South Texas Project Electric Generating Station 4000 Avenue F – Suite A Bay City, Texas 77414

October 5, 2009
U7-C-STP-NRC-090160

South Texas Project
Units 3 and 4
Docket Nos. 52-012 and 52-013
Response to Request for Additional Information

FIGURE 03-08-04-15A
CONCEPTUAL SKETCH ON INTERFACE BETWEEN THE RSW PIPING TUNNEL
AND BUILDING

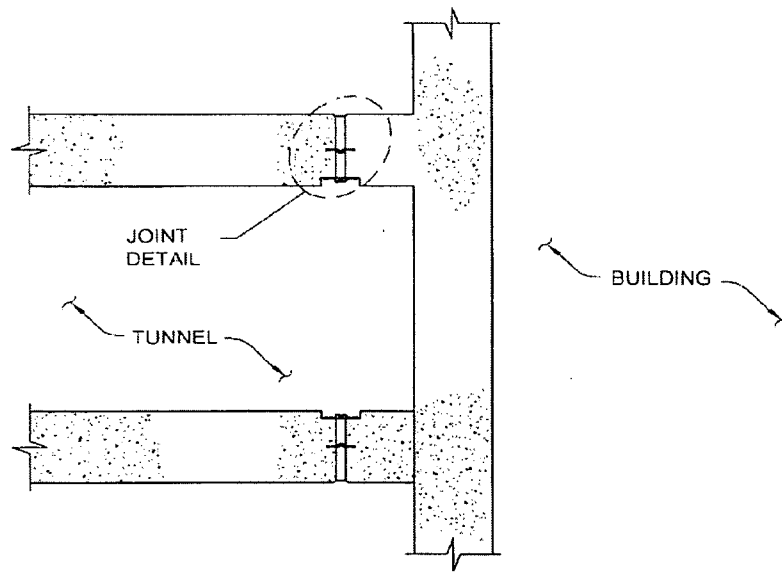
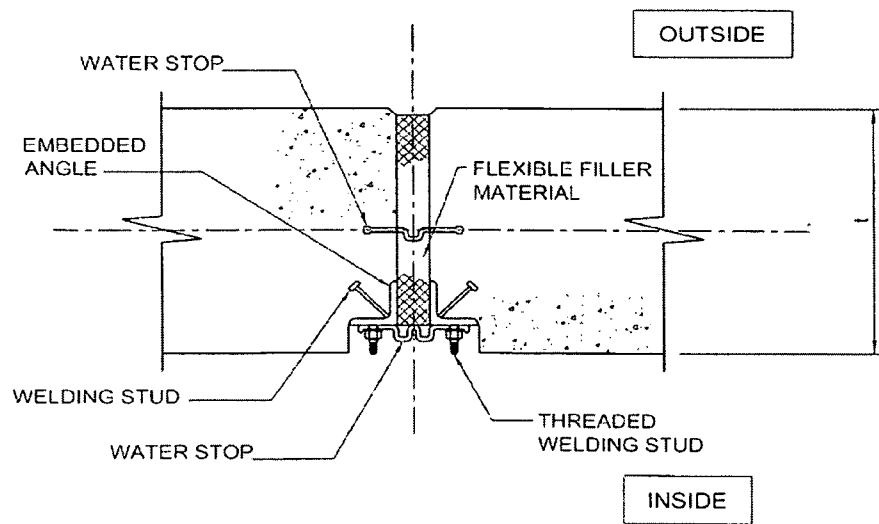
In FSAR Section 3H.6.3.4, "Reactor Service Water Piping Tunnels," the applicant stated that "The interfaces between the tunnels and the pump houses and control buildings are configured to allow relative movement between the tunnels and structures." Please provide a description of the interface configuration between the tunnels and the pump houses and the control buildings. Please also describe the analysis and design methodology for the interface including the loadings and load combinations used, and the amount of relative movement considered in the design along with technical basis, and demonstrate that the flexible connection used at the interface is adequate for the design loads and deformations.

A conceptual detail of the interface between the Reactor Service Water (RSW) Piping Tunnels and the RSW Pump Houses and the Control Buildings is shown in the attached Figure 03.08.04-15A. This detail allows the flexibility to accommodate the relative movements between the buildings and the tunnels. The gap between the tunnels and the buildings is specified to accommodate the calculated relative movements due to seismic displacements and differential settlement. The interfaces will be designed to the applicable loads and loading combinations described in COLA Part 2, Tier 2, Section 3H.6.4.3. The calculations and design of the interface will be finalized as part of the detailed design.
